**From:** Simon Brodrick <sbdesignservices@yahoo.co.uk>
**Sent:** 03 May 2011 22:26
**To:** Peter Devonport
**Cc:** I Tully
**Subject:** Re: WB/11/0165/FULL: 95 Hayling Rise Worthing: side extension and roof alterations
**Attachments:** Tully A4 Rev B.doc

| PROJECT<br>Proposed single storey extension at side and alterations to roof to provide additional accommodation at<br>95 Hayling Rise, Worthing, BN13 3AQ<br><br>CLIENT Mr & Mrs I Tully | Scales<br>1:50, 1:100<br>1:500, 1:1250<br><br>Date<br>Feb 2011<br><br>Drawn<br>srb | Revisions<br>A) May 11 Dormer elevations amended<br><br>Drawing No 15/11/02 1A |

# Proposed Elevations

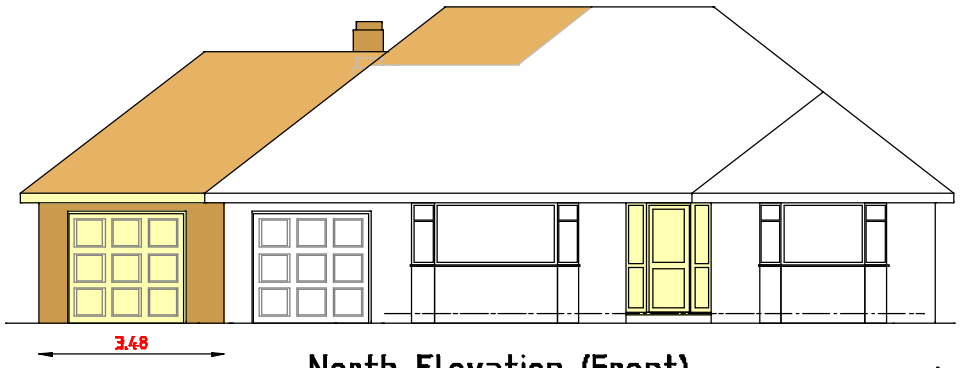
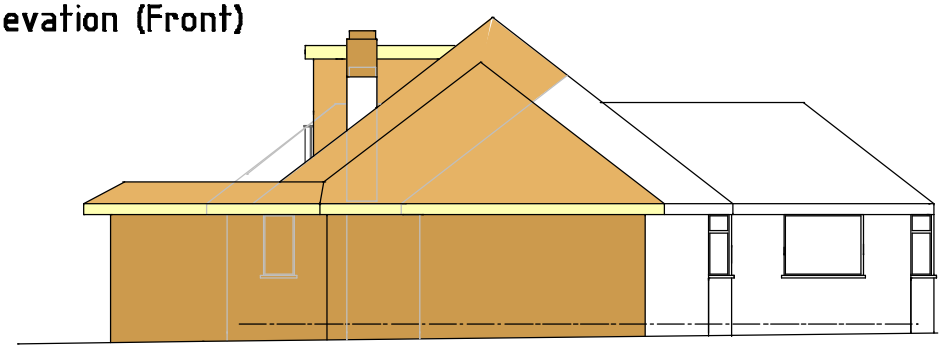
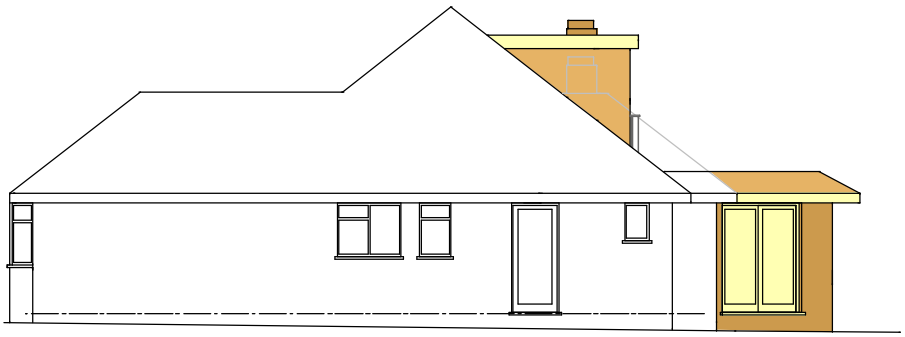
My suggested way forward in relation to the originally submitted scheme would be to remove the combination roof over the rear dormers and make it flat; remove the central projection in the dormer to make it flush with the main wall and reduce the width of the box dormer so created by 0.5ms each side to give the dormer more breathing space in the roof slope. I have since received an objection from a neighbour on the overlooking that the dormer would create and I believe the above changes will also reduce the perception of the dormer/Juliet balcony being too invasive.

Whilst I do not find the side extension problematic, I do have major concerns over the rear dormer. This is large and awkward, and, the bungalow being on a bend, is exposed and obtrusive from the street. There is clear scope for a rear dormer of some sort and to incorporate a Juliet balcony but this needs to be scaled down. A significant rethink is necessary.
